SUBJECT: **El Segundo Power Redevelopment Project (00-AFC-14C)**
Addendum I to the Staff Analysis of Proposed Change to Dry Cooling
and Other Project Changes

STAFF ANALYSIS ADDENDUM I

**Response To Comments On
The Staff Analysis Published June 12, 2008**

LAND USE - FIGURE 5

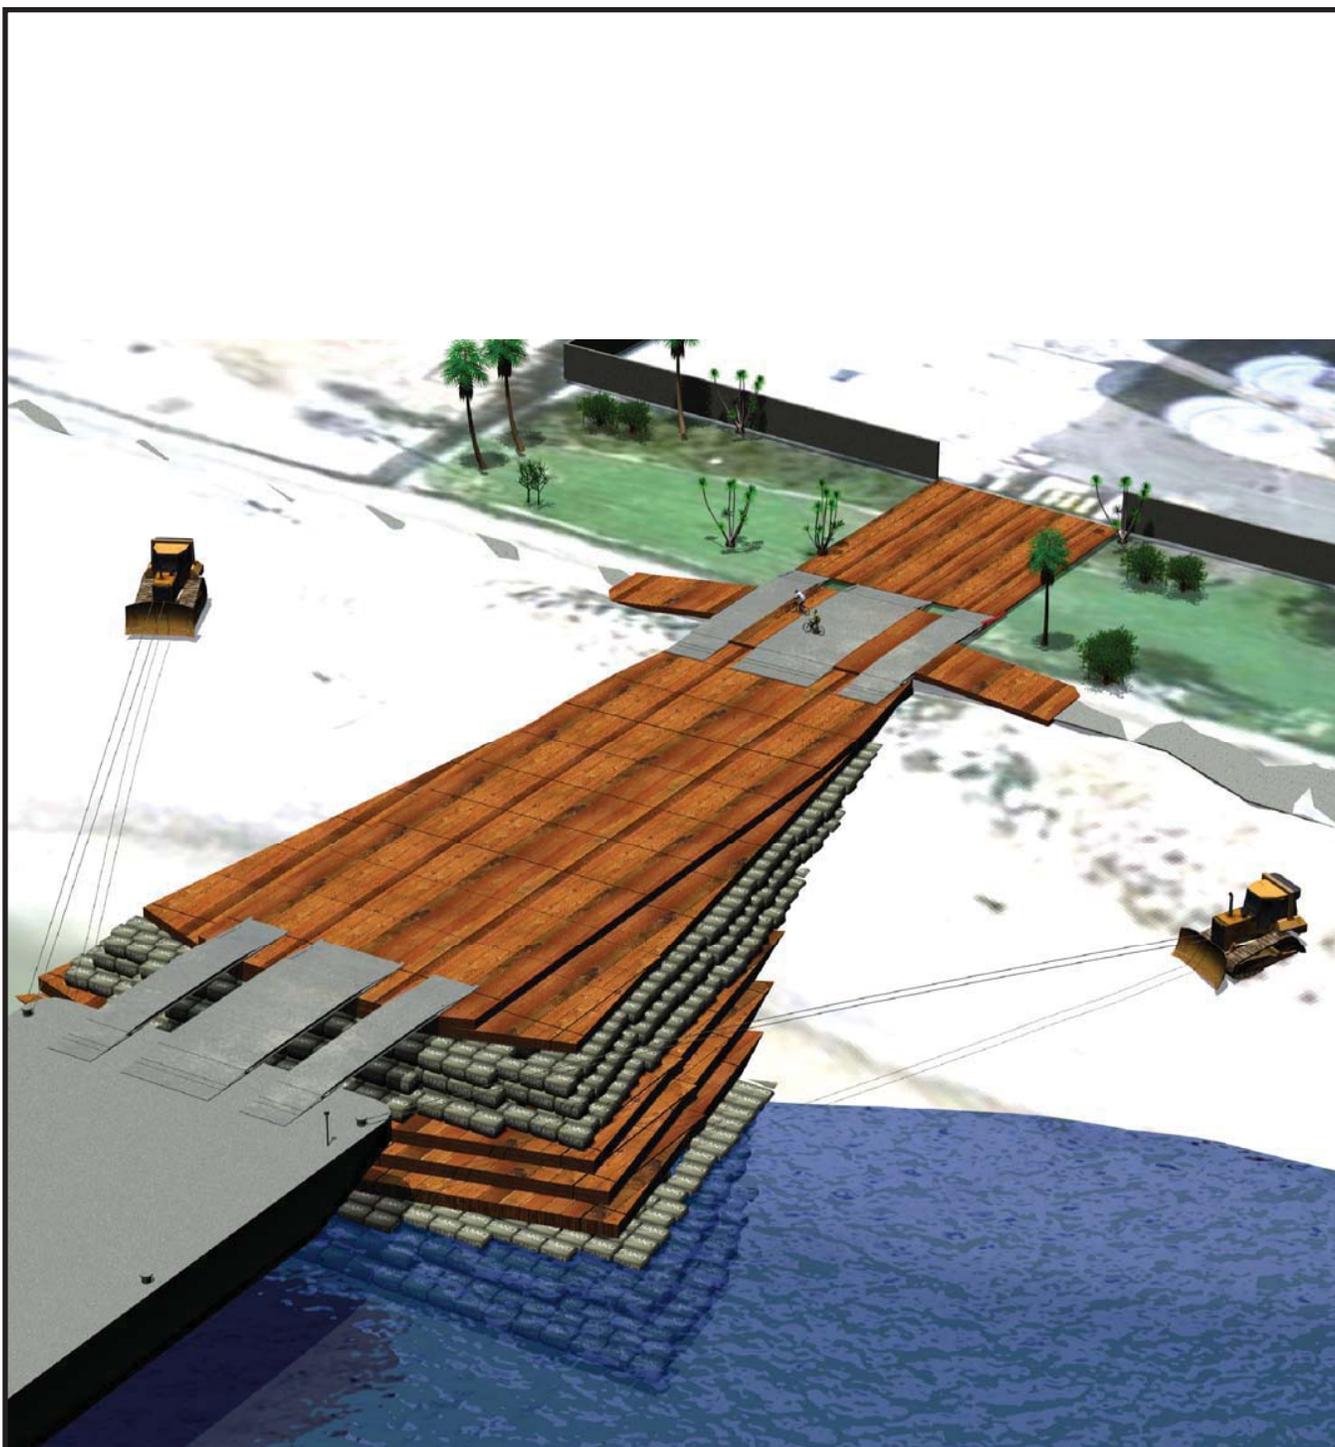
The project owner is considering a beach delivery option for new oversized equipment (e.g., steam turbine generators, heat recovery steam generators, air-cooled condensers). This option would close for public use an approximate two-acre area west of the El Segundo Generating Station property for an approximate six-month period (construction period). The two-acre area extends from the northwest corner of the El Segundo Generating Station property to the surf zone of Santa Monica Bay (**Land Use Figure 1 – Aerial Photo of Proposed Beach Delivery Path and Existing Bicycle Path**).

During the beach delivery phase, beach users would not be able to use an approximate 300-foot by 300-foot (2 acres) beach area west of the El Segundo Generating Station between Dockweiler State Beach and Manhattan Beach (**Land Use Figure 3 – Beach Area West of the El Segundo Generating Station**). This beach area, owned by the project owner, is to be traversed by an approximate 250-foot long beach ramp made of geo-tech fiber, wood matting and sandbags with an access ramp extending over the bicycle trail into the El Segundo Generating Station. The access ramp would include closure gates across the bike path to prevent public access to the beach ramp during deliveries. Fencing for safety and security purposes would be installed around the beach delivery area (**Land Use Figure 4 – Conceptual Layout of Beach Delivery Area**). **The project's proposed ramp crossing the beach to move oversized equipment from barges docked in Santa Monica Bay to the project site may affect beach operations conducted by the LACDBH (Land Use Figure 5 – Beach Ramp Rendering).**

Modified Conditions of Certification and Revised Figures 5 and 6:
